ALFIERI ACRES ADDITION
SEDGWICK COUNTY, KANSAS

RE: SUB 2000-13 -- Final Plat of ALFIERI ACRES ADDITION

RE: SUB 2000-13 -- Preliminary Plat of ALFIERI ACRES ADDITION

CASE NUMBER: SUB 2000-13 -- ALFIERI ACRES ADDITION

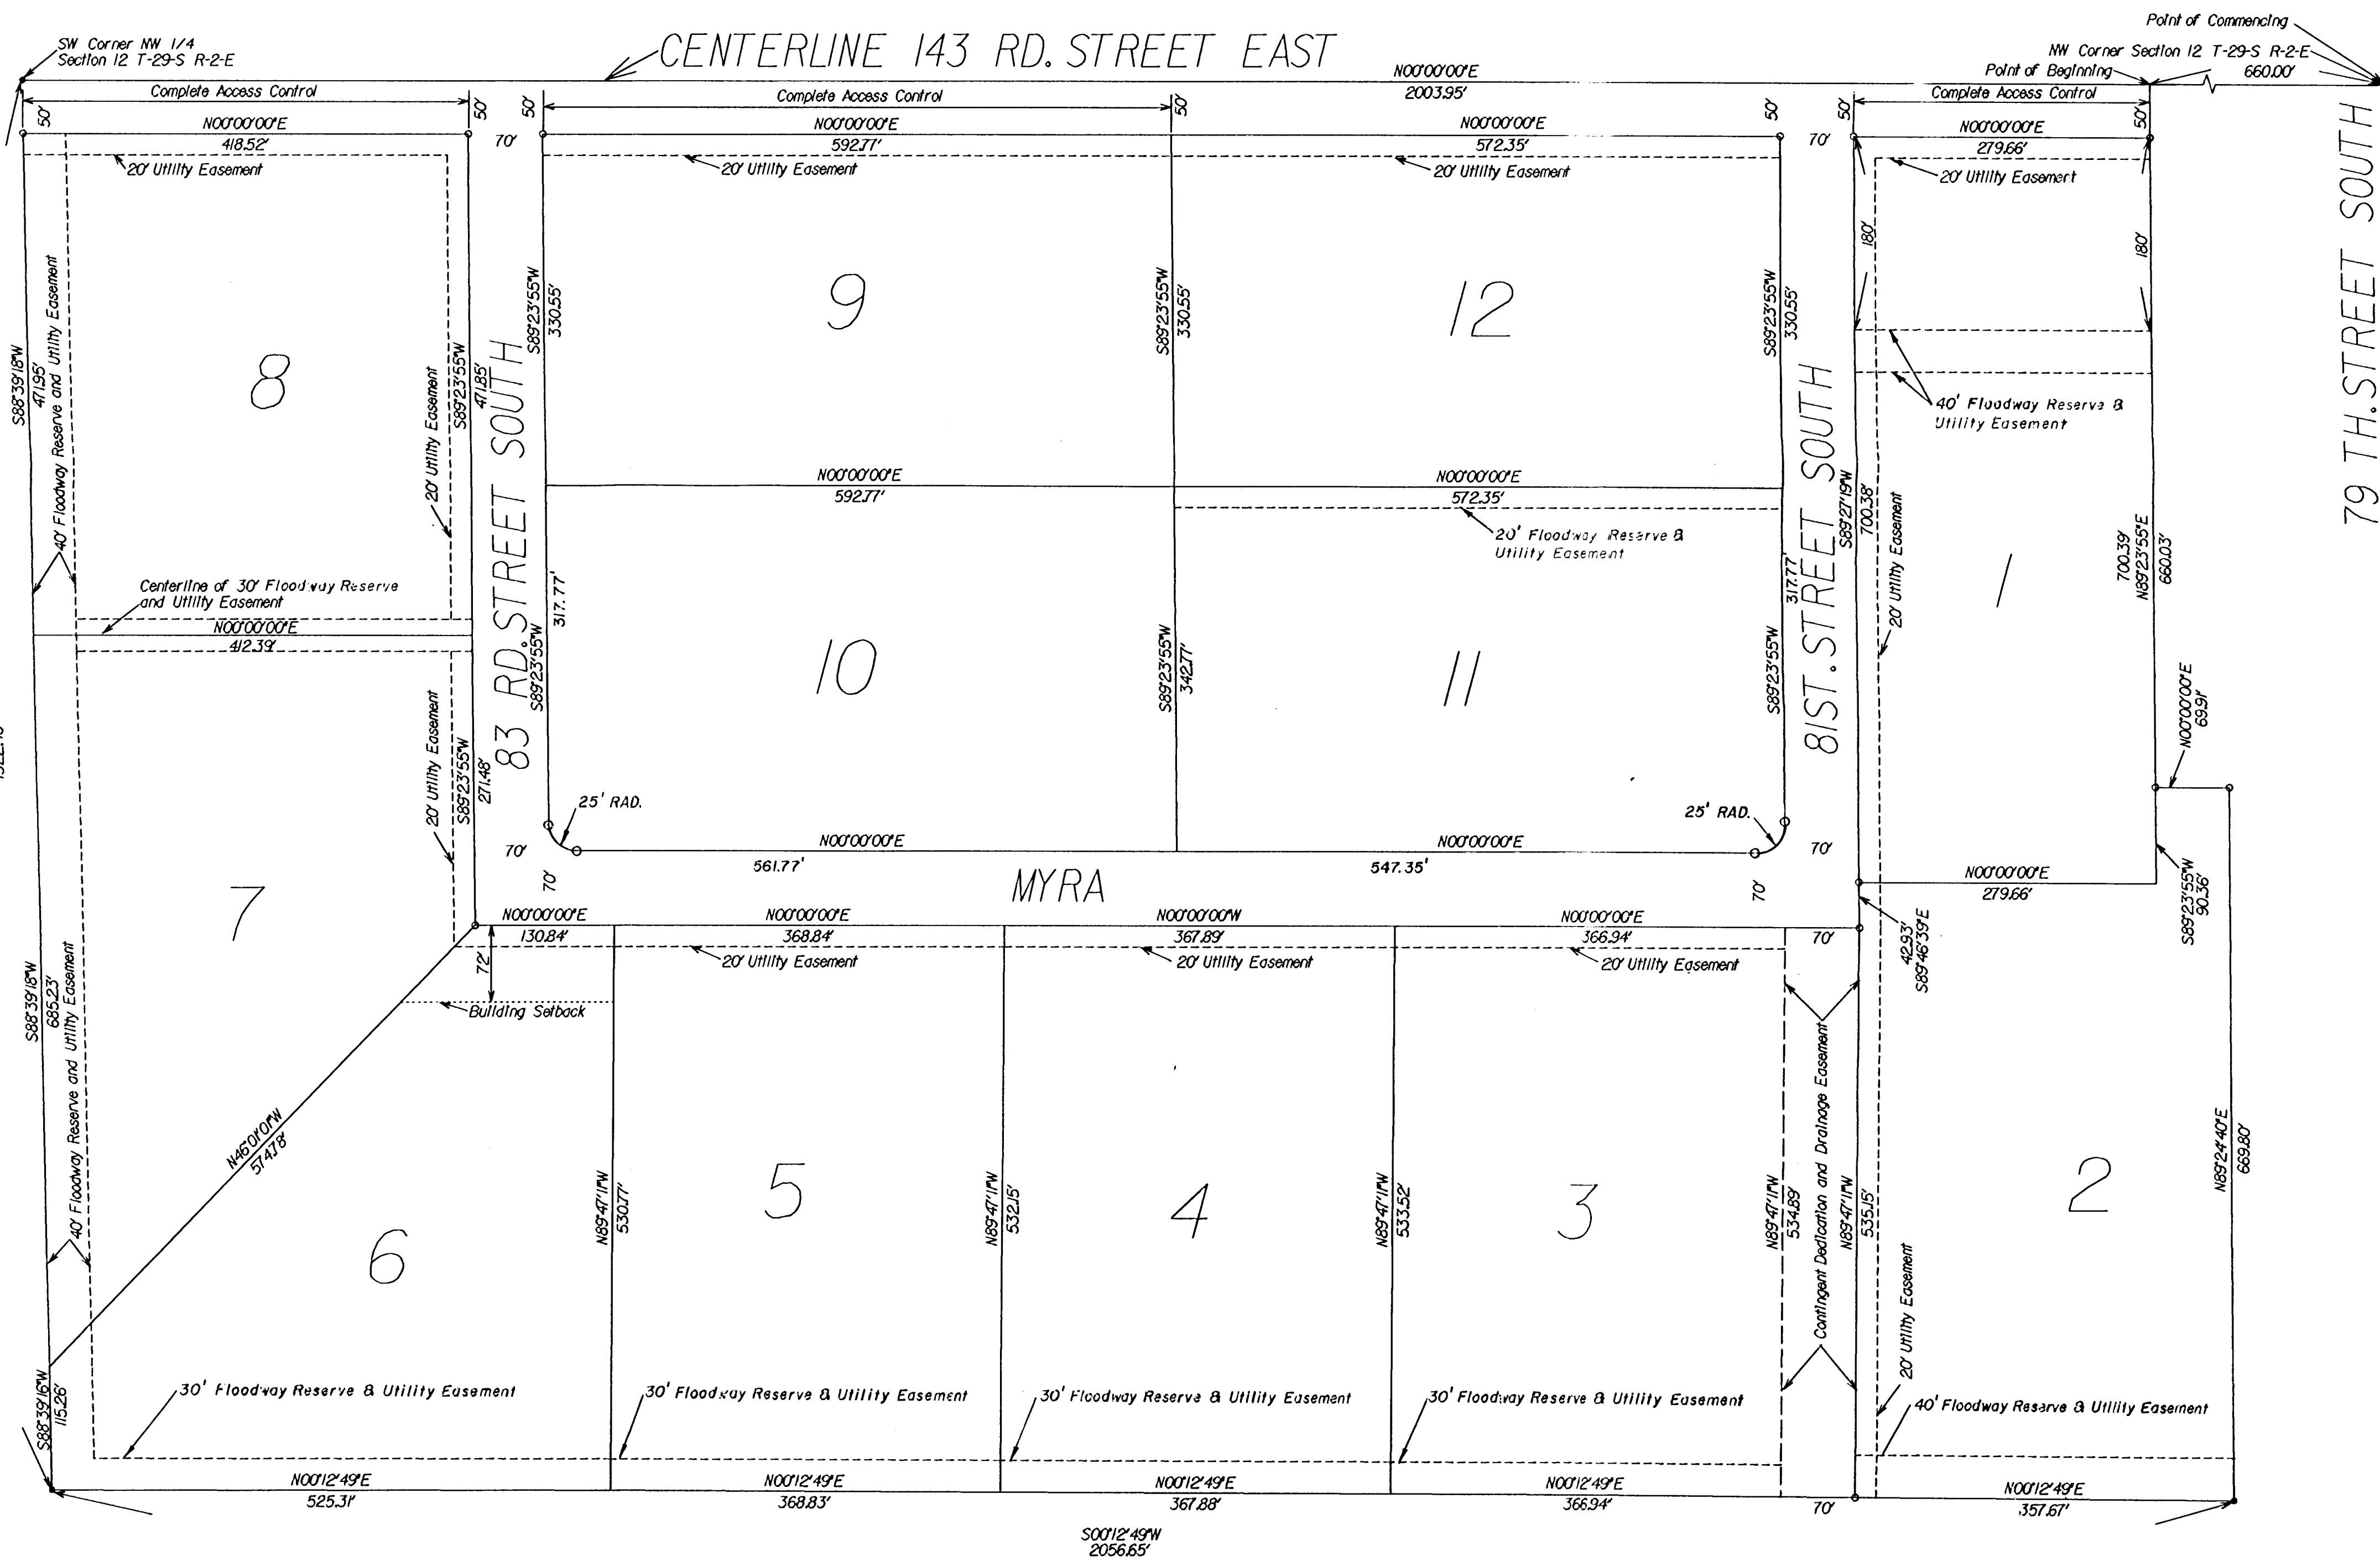
- D. County Engineering needs to comment on the status of the applicant's drainage plan. A dedicated Floodway Reserve is required along the south line of Lot 8. The drainage easements should be labeled as "Floodway Reserves". The Applicant shall coordinate the modification or removal of terraces with NRCA.

- E. The final plat shall contain the standard floodway language in the plat's text.
- F. The centerline of 143rd Street East shall be denoted.
- G. County Fire Department needs to comment on the plat's street names.

- I. The applicant shall guarantee the installation of the proposed interior streets to the suburban street standard.
- J. The south line of the contingent right-of-way dedication should be denoted with a dashed line. The east and west line of the contingent right-of-way dedication should be denoted with solid lines.

- K. The contingent right-of-way dedication shall be referenced in the plat's text.
- L. Lot 6 does not contain the required 200-ft lot width at the front property line. An increase in the distance of the building setback from the road is needed to meet the standard.

- M. The dimensions should only include two decimal places.
- N. A radius is required on the northeast corner of Lot 11 and the southeast corner of Lot 10.

- O. The outparcel should be included as part of the plat.

- P. The distances and degrees on the drawing need to coincide with those in the legal description.
- Q. The platlor's text shall include language that a drainage plan has been developed for the plat and that all drainage easements, rights-of-way, or reserves shall remain at established grades or as modified with the approval of the applicable City or County Engineer, and unobstructed to allow for the conveyance of stormwater.

- Y. The representatives from the utility companies should be prepared to comment on the need for any additional utility easements to be platted on this property. **Southwestern Bell requests additional easements.**
